MILITARY SPECIFICATION
SEMICONDUCTOR DEVICE, TRANSISTOR, NPN, SILICON, POWER
TYPES 2N4865, 2N5250, 2N5251 and
TX2N4865, TX2N5250, TX2N5251

Figure 3. Pulse Response test circuit(s).

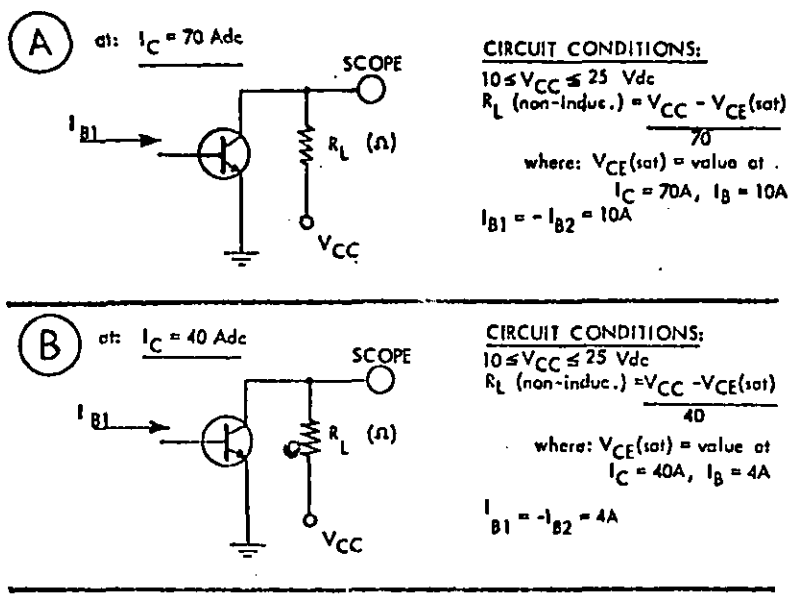
Figure 3: Replace with new Figure 3, see below.
